To: Secretary, NSW Department of Planning, Housing and Infrastructure
Re: Objection to SSD-76220734 (Indigo by Moran – 156 Ocean St, Narrabeen)

I am writing to lodge my objection to the design of the Indigo by Moran seniors housing development proposal at Narrabeen.

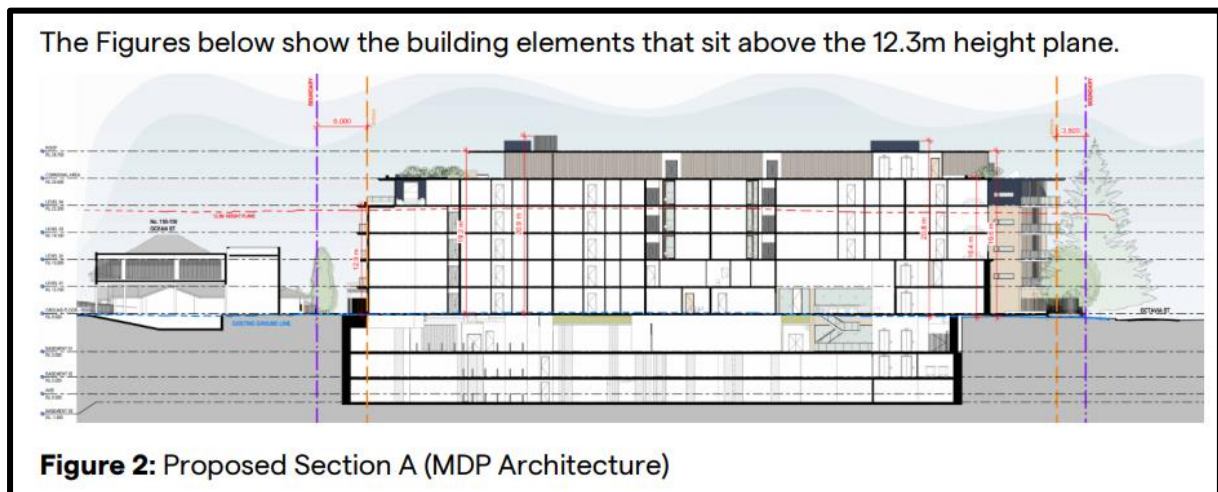
I understand the developer is relying on the 12.3m allowable height limit from the Housing SEPP rather than the 8.5m height limit that applies to neighbouring residents as part of the Warringah LEP 2011. Even with the higher 12.3m limit, this proposal is still 8.8m/71% higher than that (per figure below).

Appendix 12 (Clause 4.6 Variation Request) does not provide a valid reason for why the proposal is an additional 8.8m higher than the SEPP allows, rather just explaining “the building height non-compliance primarily relates to the fifth storey, the pavilion areas of the roof terraces along the Ocean Street frontage of the development and rooftop plant / lift overrun. Where the height breaches at the fourth storey this is primarily due to natural undulation of the existing ground level.”

Overall, appendix 12 does not appear to provide sufficient grounds to contravene the development standard. I believe it is unacceptable that the design reaches an additional 8.8m above a height limit that is already markedly higher than what is available to surrounding residences for no clear reason other than what I assume is a desire from the developer to build additional units to sell.

All buildings in the redevelopment (including pavilions, terraces and rooftop plan/lift overrun) must remain under the 12.3m limit allowable under the Housing SEPP, especially given this is still 1.5x higher than the 8.5m limit that applies to the rest of the neighbourhood through the Warringah LEP.

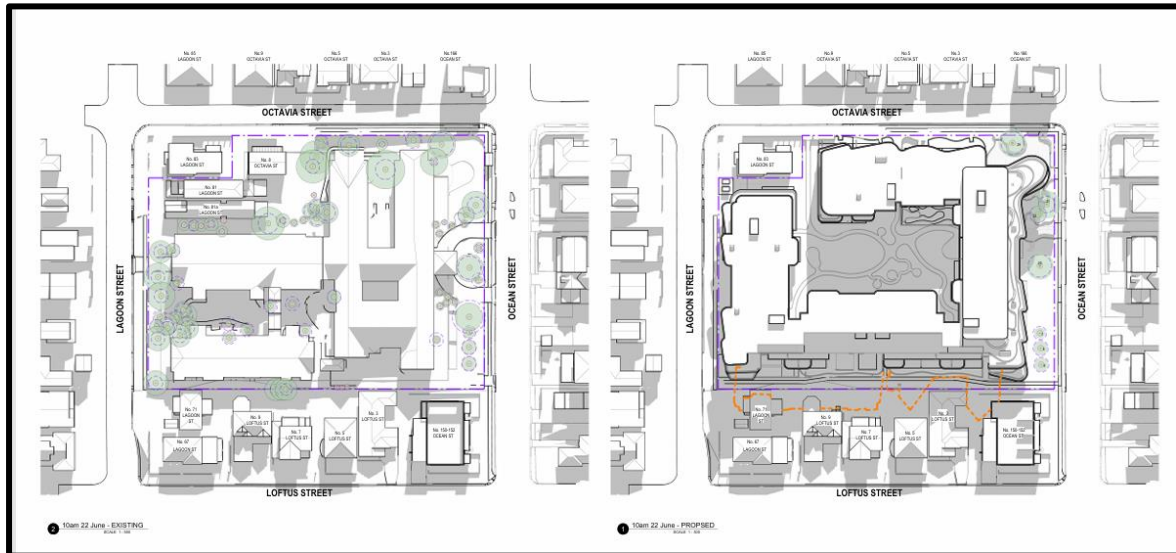
The shadow diagrams such as the excerpt below provided in Appendix 1 (Architectural Drawings) show a significant increase in shadowing on adjacent residents on the Loftus Street side as a result of the redevelopment. It seems the height of the buildings and close proximity to the boundary result in unreasonable negative impacts on these adjacent properties with an extensive loss of direct sunlight.

The height of the redevelopment be lowered at the Loftus St end of the site in particular to reduce shadowing on adjoining properties, and increased setbacks/additional boundary vegetation be required to minimize shadowing and loss of privacy for neighbours.

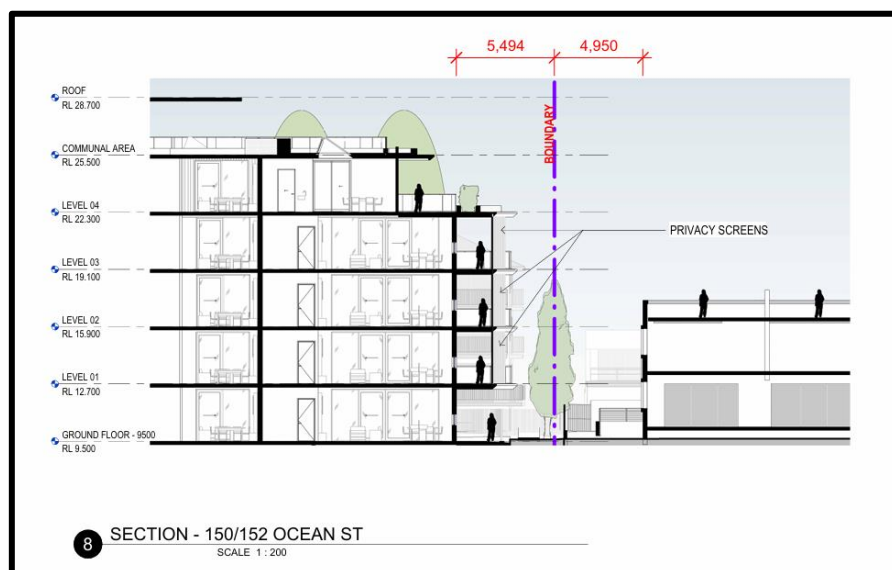
It is disappointing the current design appears to build the units close to the boundary to increase the green space/internal courtyard for residents at the expense of the privacy of surrounding neighbours. The cross section shown below from Appendix 1 (Architectural Drawings), shows the units at the southern end of the site being built incredibly close to the boundary with the adjacent unit block at 150 Ocean Street. For the units at the northern end of this existing residential building, the lack of setback and sheer height of the redevelopment creates unacceptable overshadowing and loss of privacy, especially to these residents outdoor space/rooftop terrace.

This design does not appear to be in keeping with the NSW Government *Seniors Housing Design Guide (November 2023)* design guidance (4.3) regarding the need for setbacks. This guide outlines that generous setbacks enhance the enjoyment of residents and to observe privacy of the adjacent neighbouring properties.
